RICHMOND COMMUNITY SCHOOL
Richmond High School: Mechanical Modernization Project
LWC Commission No. 20104.02

ADDENDUM #03
October 3, 2021

3 BOILER HOUSE LOWER LEVEL POWER & SYSTEMS PLAN
SCALE: 1/8" = 1'-0"

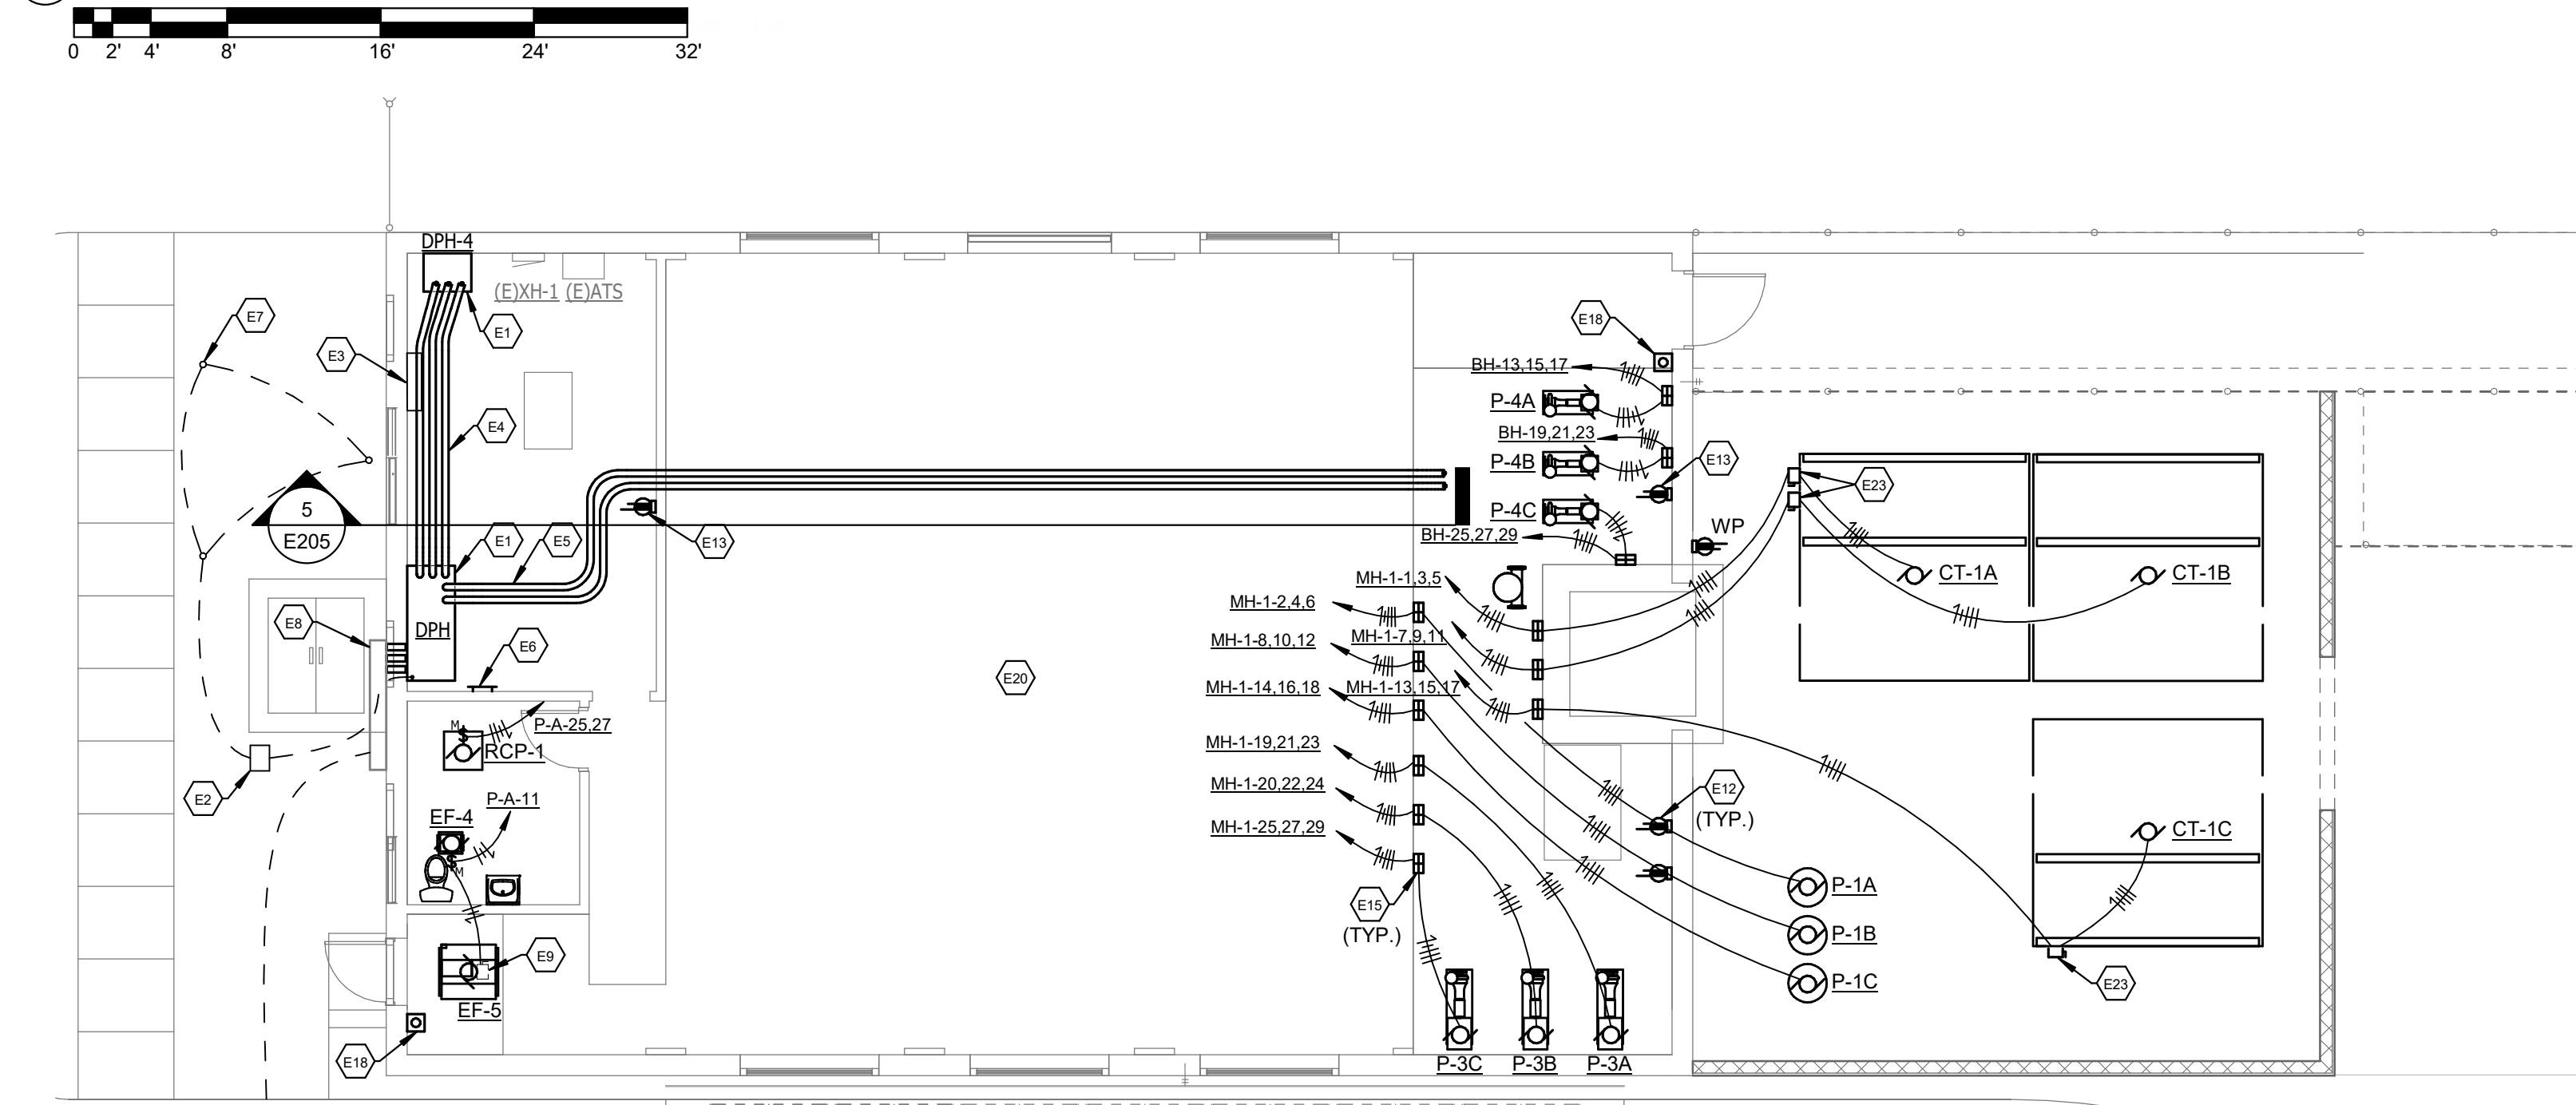
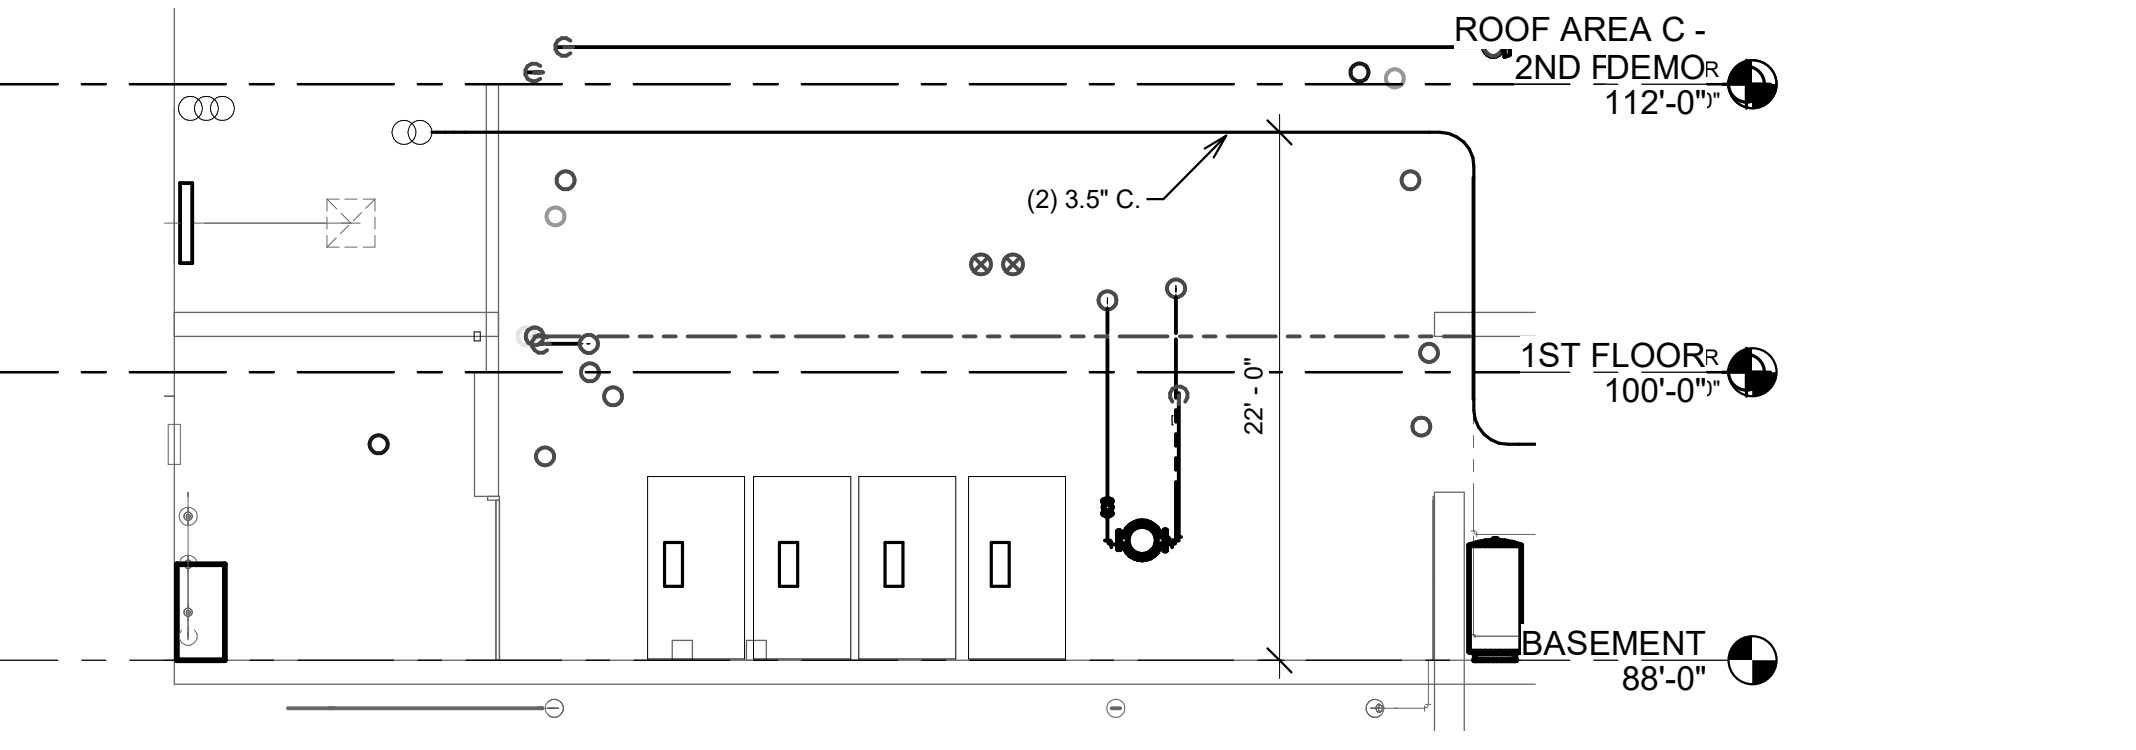
ITEM NO.12 Drawing E205

Comm. No.	Date
	20104.02	08.27.2021
	Drawn	Drawing No.
	NGM	E301
Checked	JAE

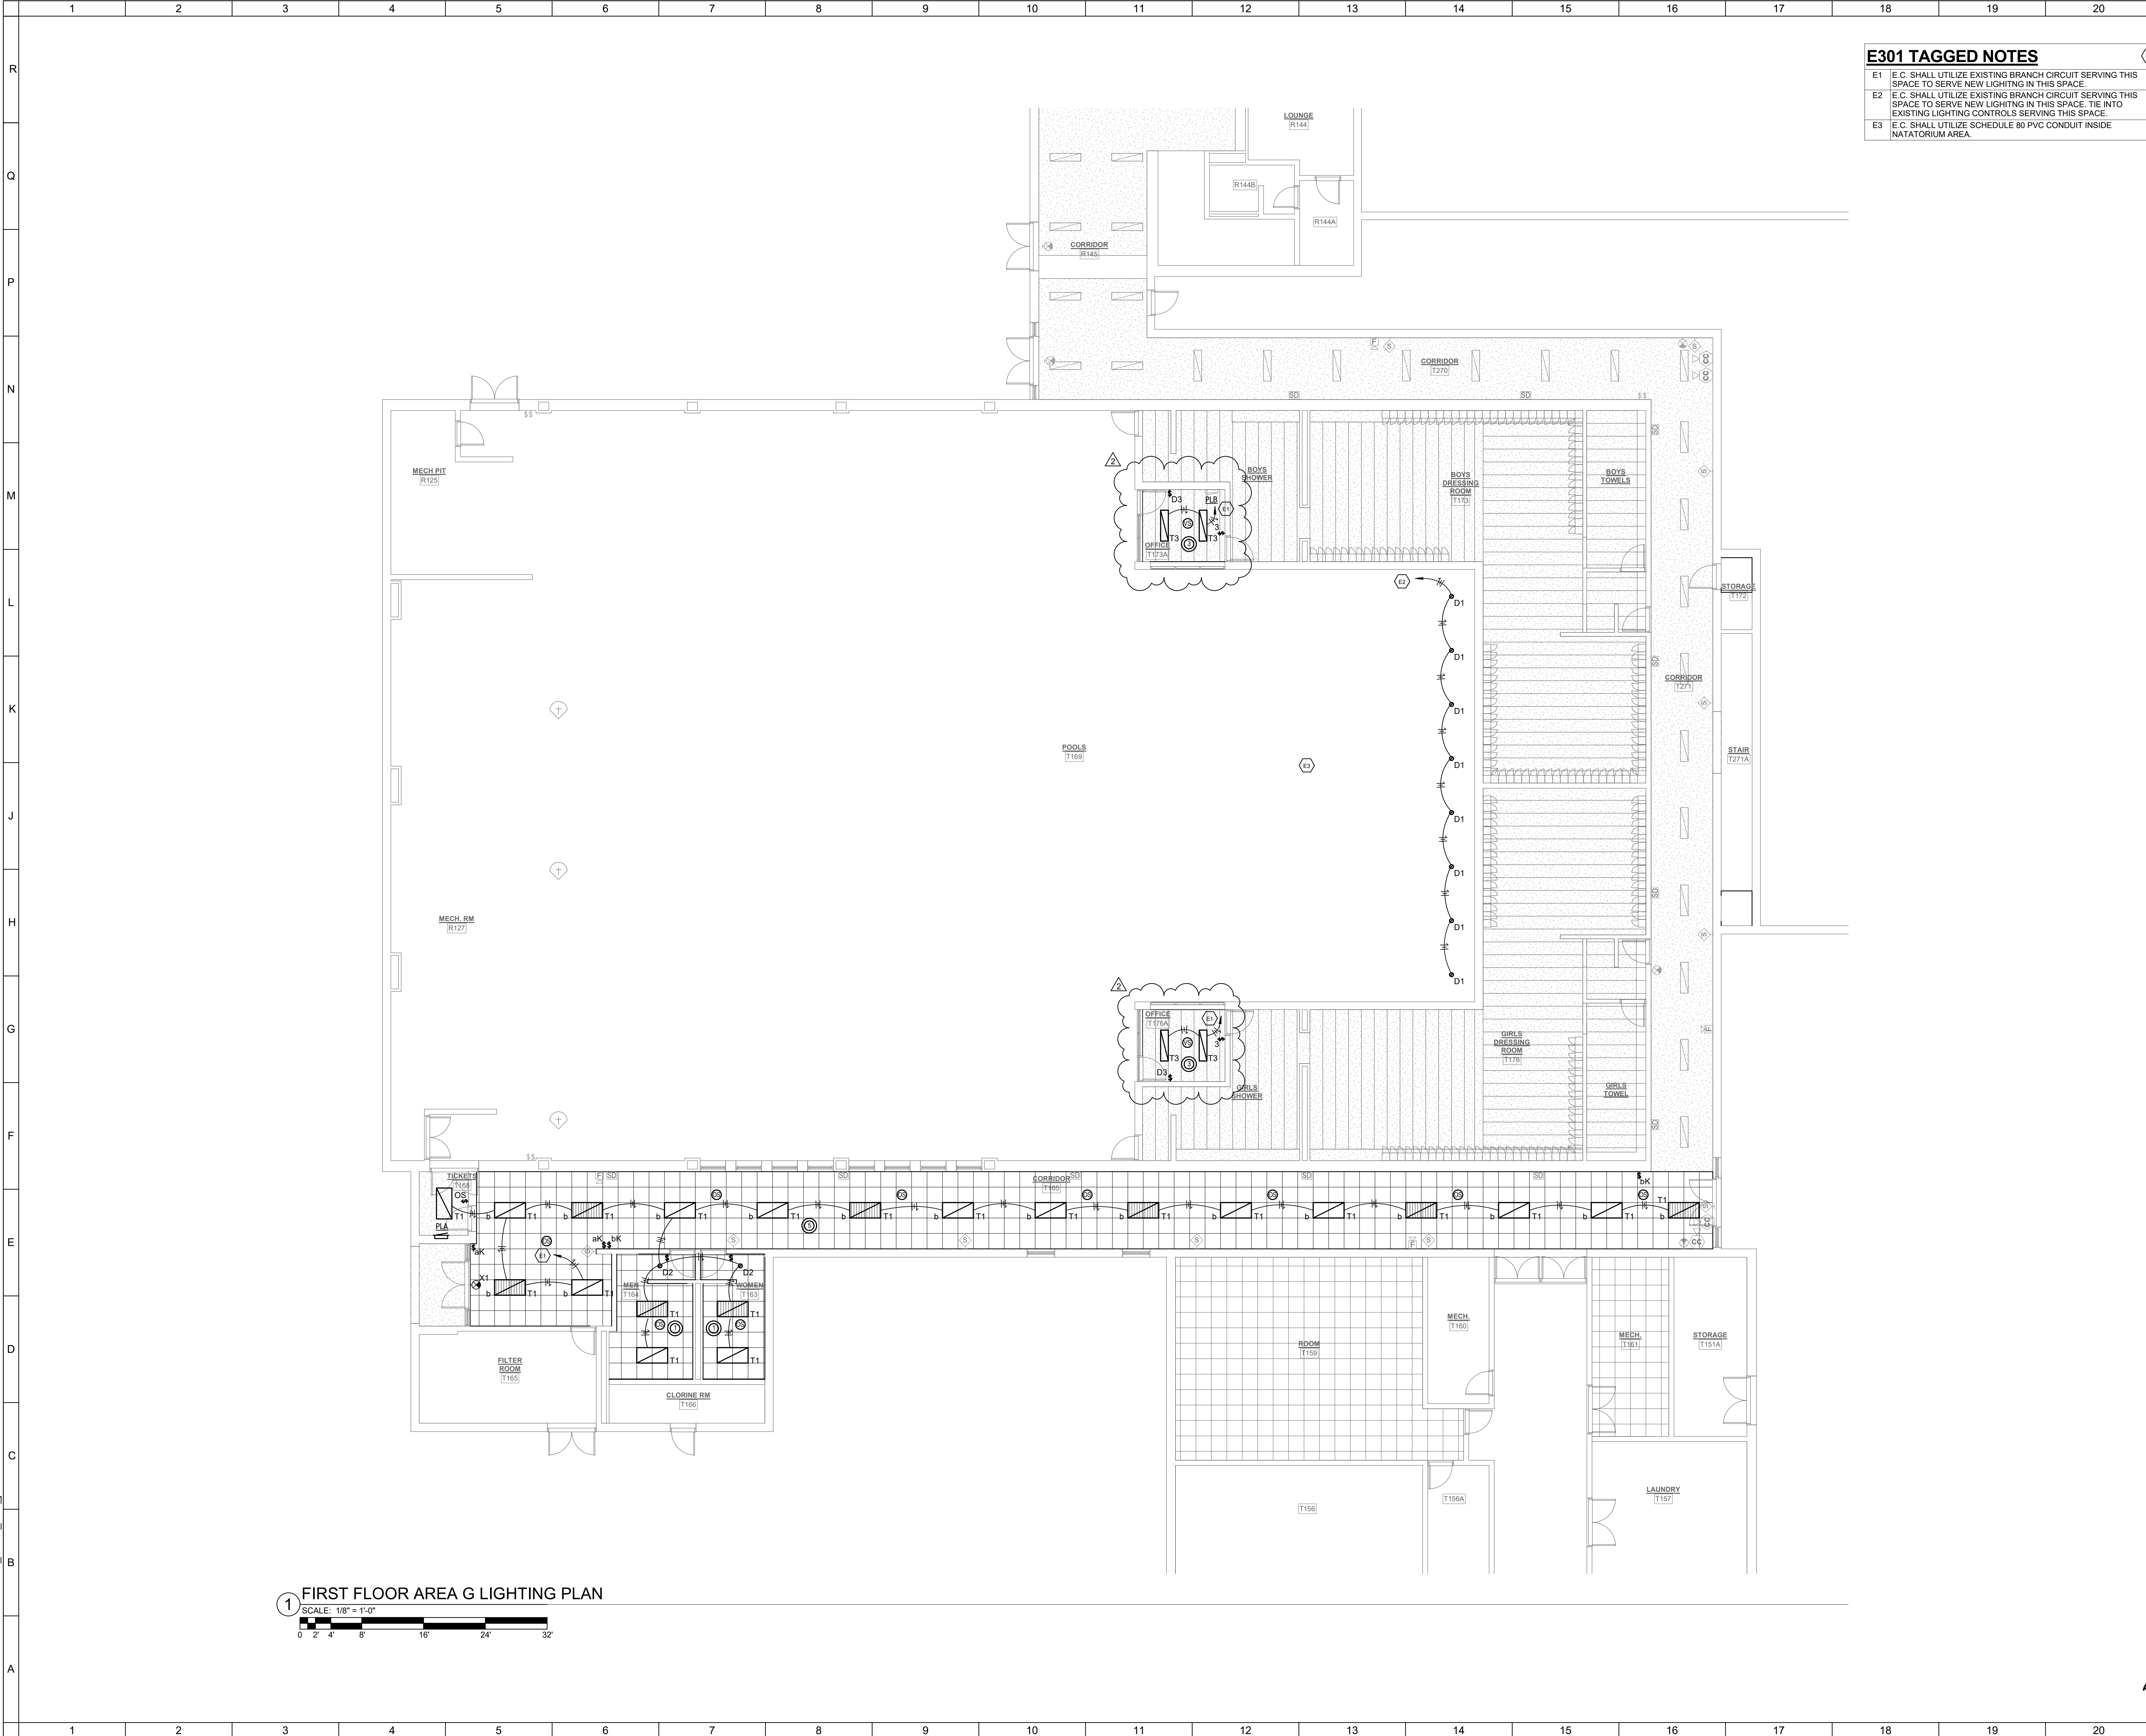
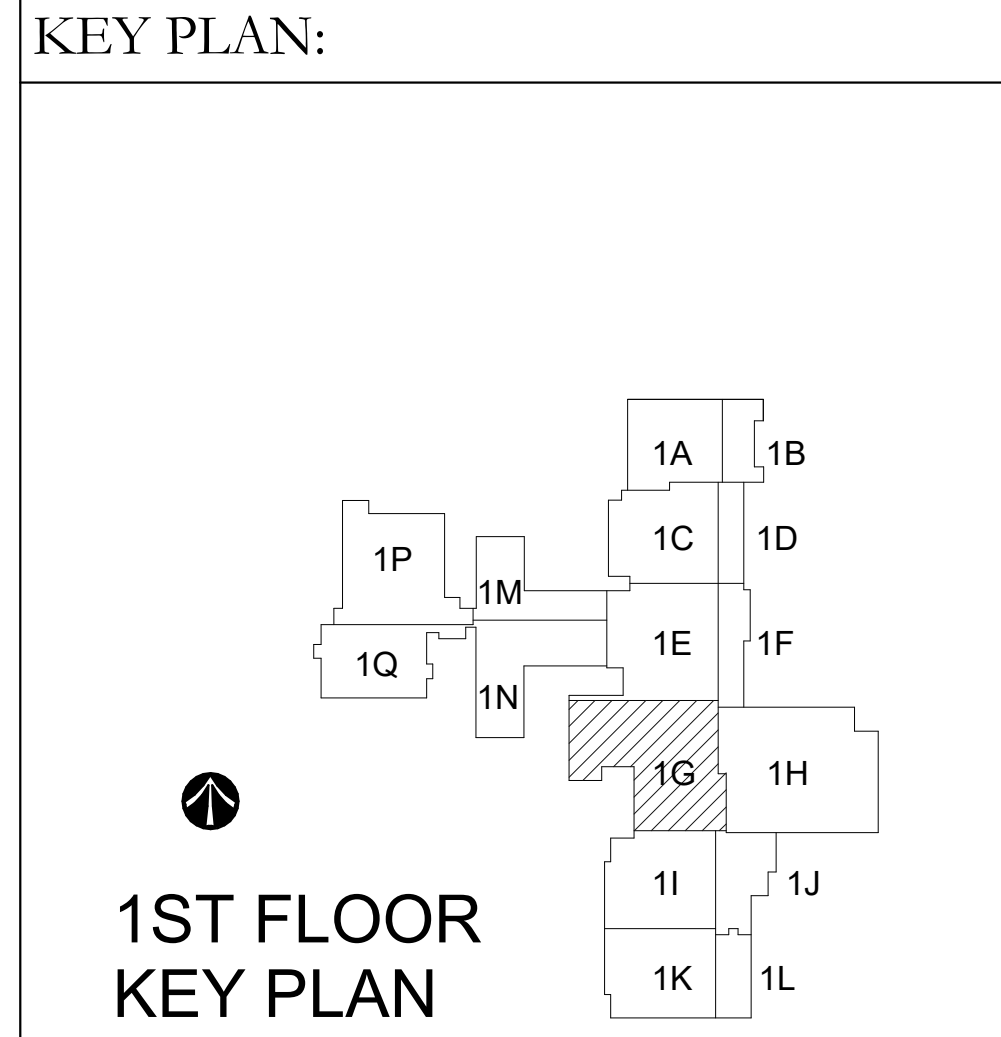
ITEM NO.13 Drawing E301

- A. Added lighting and lighting controls to natatorium offices T173A and T176A.
